## Notice About Adding Production-site of K7 DC Type Relay

Anglia have been informed by the supplier OKO that they have implemented some adjustment on production of the listed K7DC (direct current) type relay. A new production-site has been added in Xiamen in which the listed DC type relays will be produced by automatic production line. Please see below for the changes :

The vent hole change's :

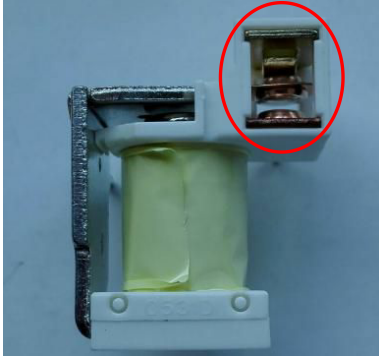
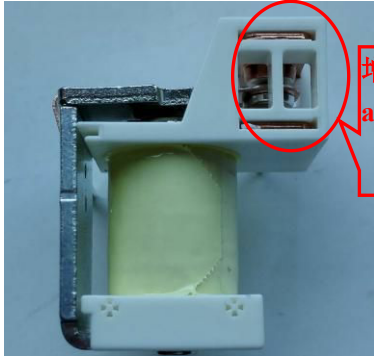
original production-site UV glue sealing vent hole	new production-site hot sealing vent hole
 A photograph of a blue K7 DC type relay. A red circle highlights a small circular vent hole on the top surface of the relay, which is sealed with a clear, viscous substance (UV glue).	 A photograph of a white K7 DC type relay. A red circle highlights a small circular vent hole on the top surface of the relay, which is sealed with a clear, solid-looking substance (hot sealing).

The parts and fixing method changes :

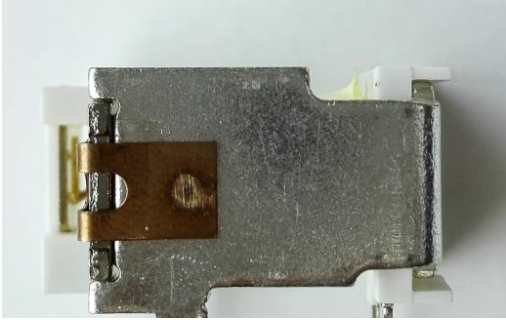
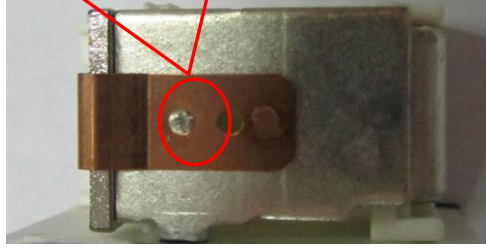
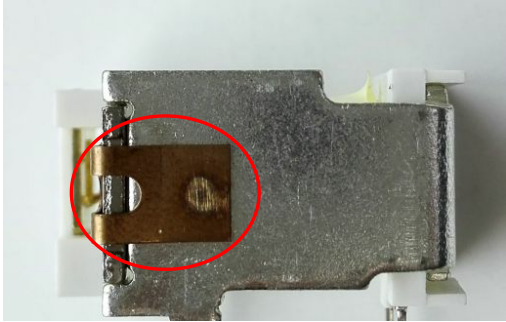
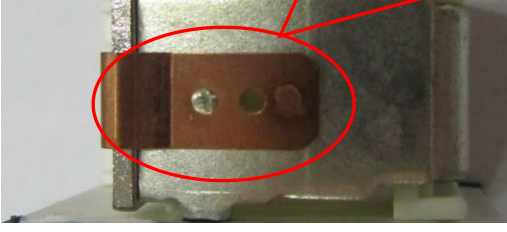
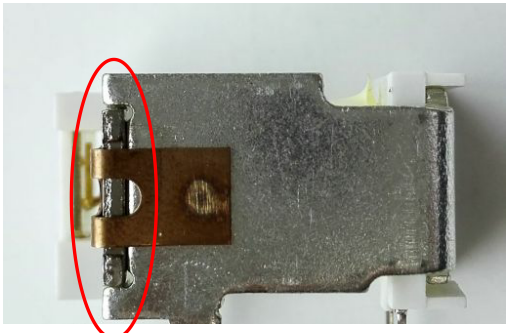
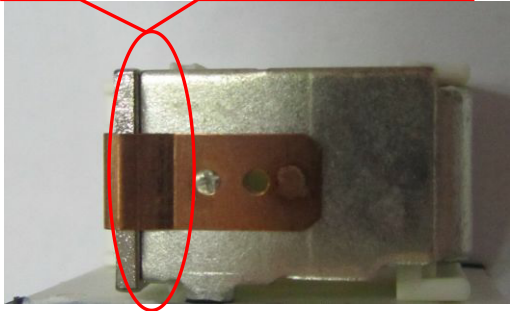
original production-site	new production-site
	 <p data-bbox="1161 349 1366 501">增加加强筋 add rib reinforcement</p>
	<p data-bbox="831 689 1337 752">增加铆压固定 add riveting fixing</p> 
	<p data-bbox="815 1043 1342 1122">动簧形状变更 moving-spring's shape change</p> 
	<p data-bbox="810 1402 1286 1480">轭铁、衔铁形状变更 yoke's and armature's shape change</p>
